SUBJECT: Customer Satisfaction Field Action 2014FA01 – Electronic Transmission Control, (ETC2) Broadcast of Transmission Selected Gear When Auto-Neutral Function Active

MODELS AFFECTED: Allison T310 Equipped Mitsubishi Fuso MP-Bus with 5th Gen Transmission Control Modules (TCM) Using Selected Gear Portion of the ETC2 Message**Introduction:**

Figure 1. Identification of Updated Calibration

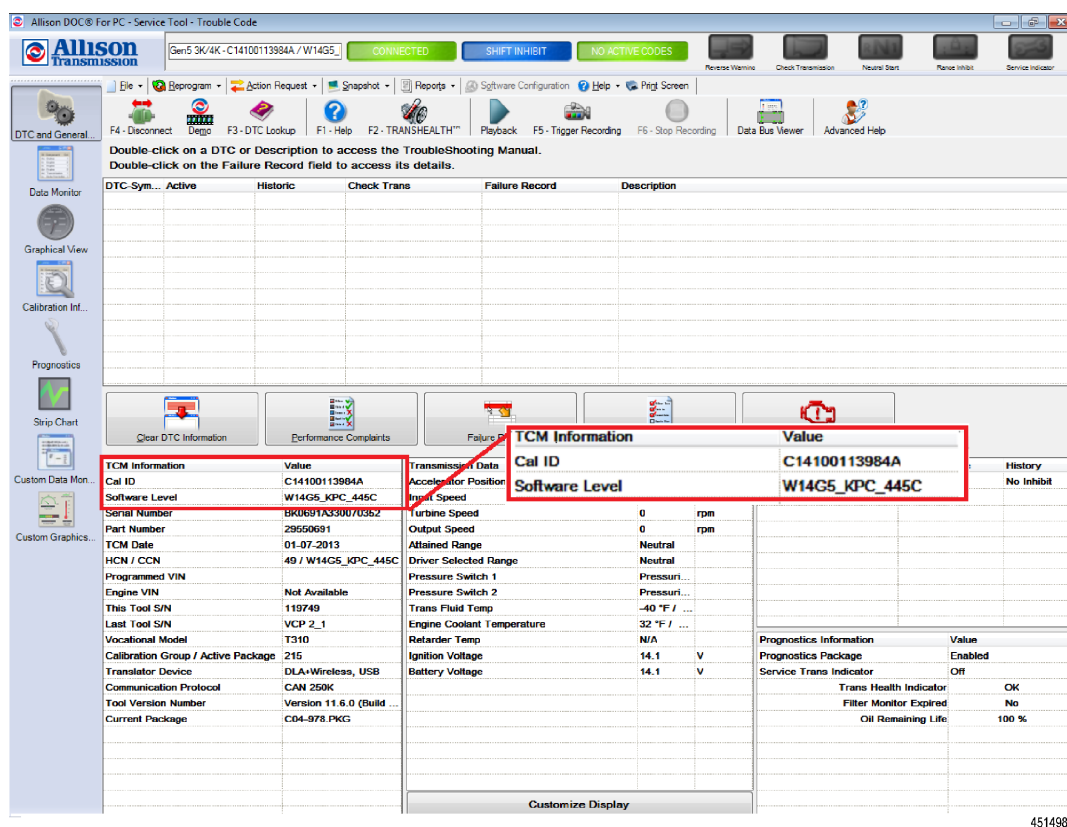
When this Field Action is completed, the vehicle should be programmed with “C14100113984A or newer”. See [Figure 1](#) of current calibration as viewed from the DTC and General view in Universal Allison DOC®.

To verify Software level after TCM reflash, close Allison TCM Reflash™ and connect Universal Allison DOC® to vehicle. Cal ID “**C14100113984A**” will be displayed on the DTC and General view in Universal Allison DOC® (refer to [Figure 1](#)).
